Environmental Assessment Addendum

Replacement Flows Project –
Cumberland Plain Woodland
community near the Quakers Hill
concentrate storage pond

November 2008

Figure 3.8 from EA

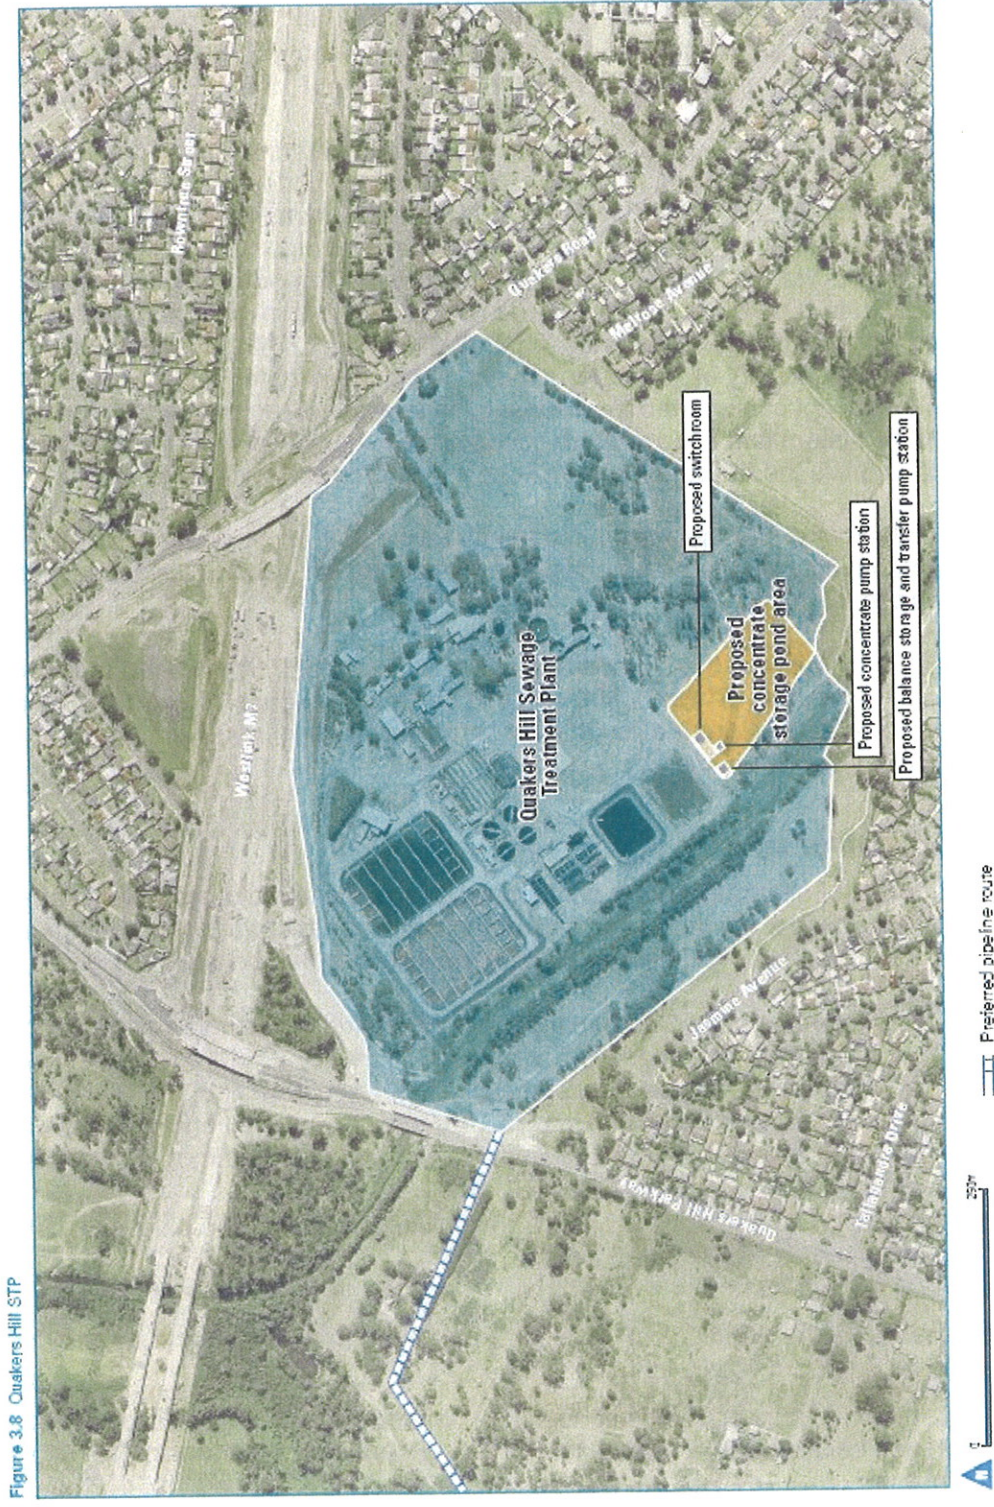
The approved layout of the concentrate pond is as indicated in Figure 3.8 of the EA. The EA indicates that the footprint of the concentrate pond is approximately 13,600 m² and states that up to 2 hectares of vegetation may need to be cleared for the concentrate pond, (EA Appendix E, Section 4.1.3).

The original location for the concentrate storage pond at Quakers Hill STP is illustrated in Figure 3.8 of the EA (extract below) and described in Section 3.6.1 of the EA:

Figure 1 Concentrate storage pond - EA and revised layouts

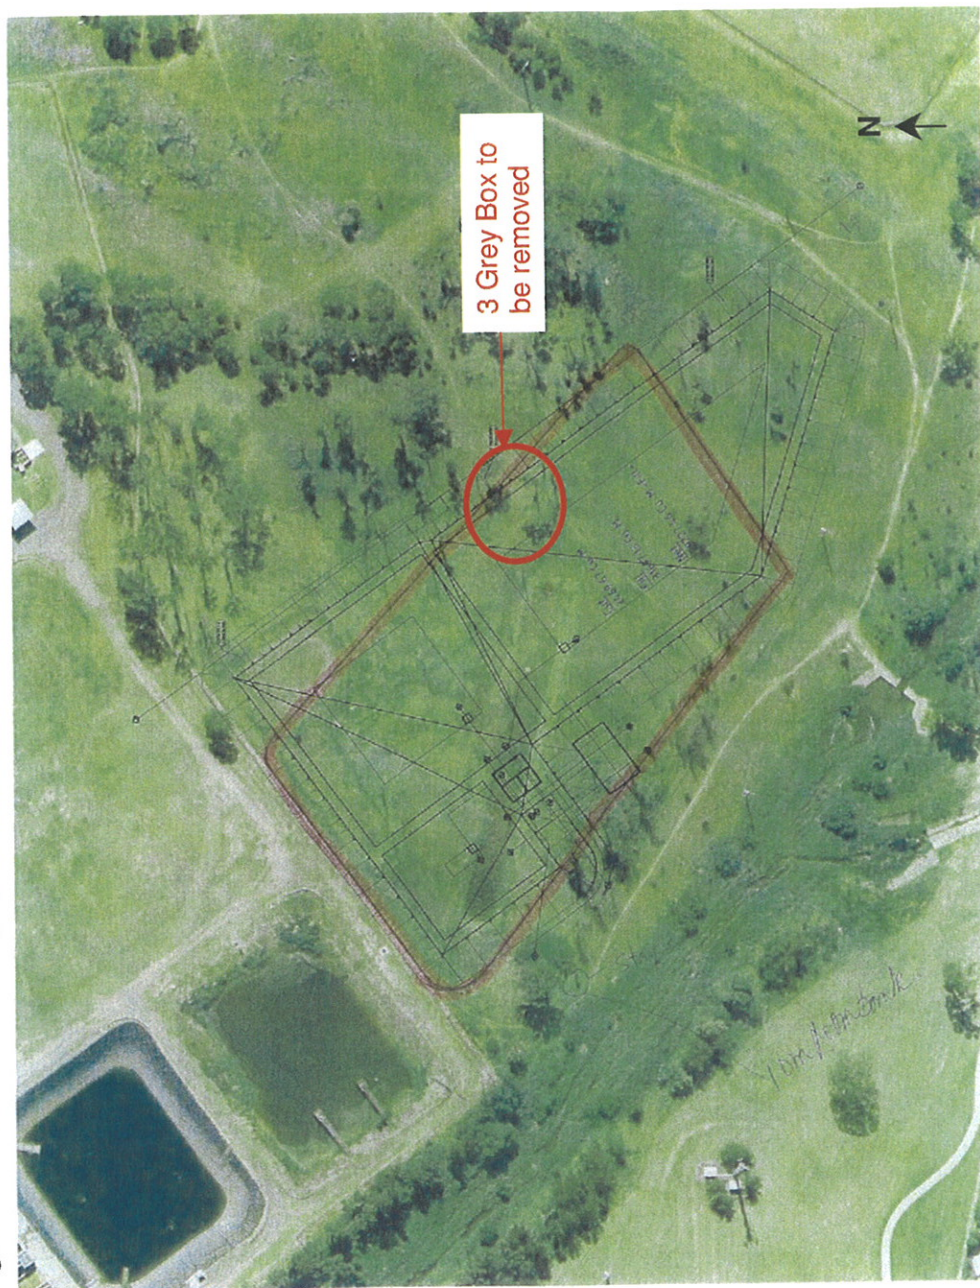
Detailed design has progressed on the layout of the concentrate storage pond at Quakers Hill STP since the contract was awarded in August 2007. **Figure 1** shows the revised footprint of the concentrate storage pond. Detailed design has identified that the concentrate pond needs to be raised above ground level to:

As a consequence, the footprint of the concentrate storage pond has increased by 7,800 m² (27%) from the footprint shown in the EA to allow for 2:1 batters. Three mature Grey Box (*Eucalyptus mollucana*) at the northern boundary of the concentrate storage pond would need to be cleared. These trees form part of the Cumberland Plain Woodland Community that is listed as an EEC under the NSW *Threatened Species Conservation Act 1995* and the Commonwealth *Environment Protection and Biodiversity Conservation Act 1999*.

The option proposed in this modification is to expand the concentrate storage pond site to the southwest, as per **Figure 1**. This Figure shows the original EA layout in pink with the revised layout and design in black. This option avoids the significant vegetation to the north, the high voltage powerlines to the south and east but involves the clearing of some River-Flat Eucalypt Forest community. In addition further surveys have identified 3 Grey Box trees which form part of the Cumberland Plain Woodland and will be cleared. These trees have been assessed by the ecologist to have minimal conservation significance.

Figure 2 Revised concentrate pond layout

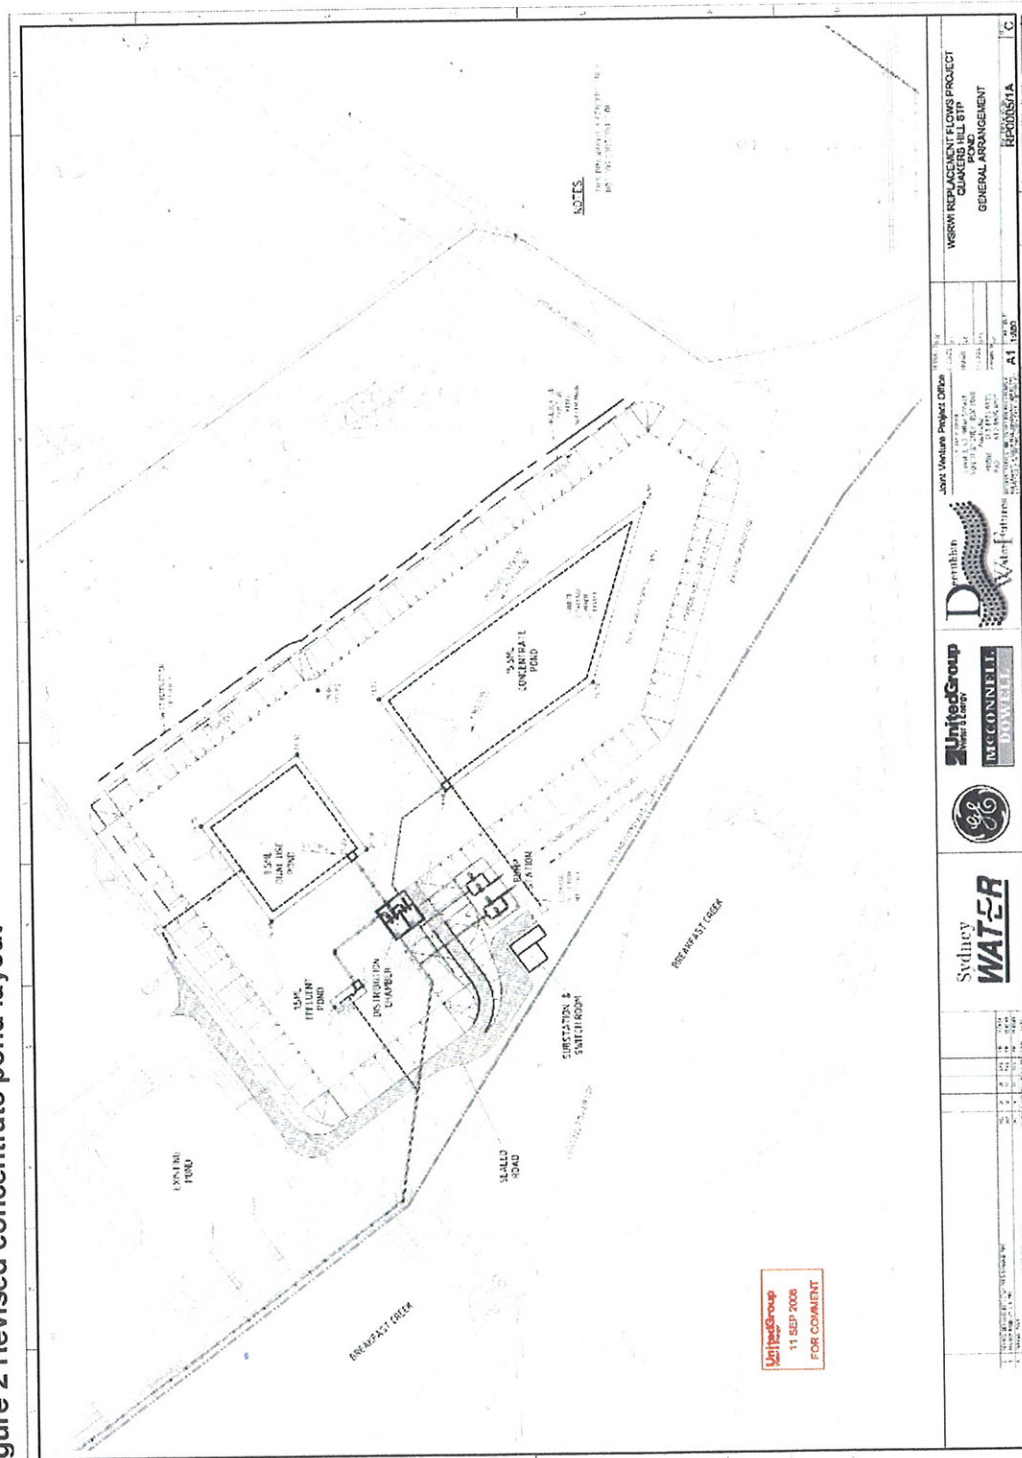
The footprint of the revised concentrate storage pond would be 21,400 m² and the layout would be as shown in **Figure 2**.

4,000 m² of River-Flat Eucalypt Forest and three Grey Box would need to be cleared for the construction of the revised concentrate storage pond. 3,800 m² of degraded, weed infested groundcover would also need to be cleared.

The construction and operation of the revised pond will not impact on the significant stand of Cumberland Plain Woodland to the north of the site and there will be a 10 m buffer to the banks of Breakfast Creek to the south. A 4-5 m working distance from the high voltage powerlines would be maintained to ensure construction and operations are within the TransGrid requirement for a 3 m distance from work or plant.
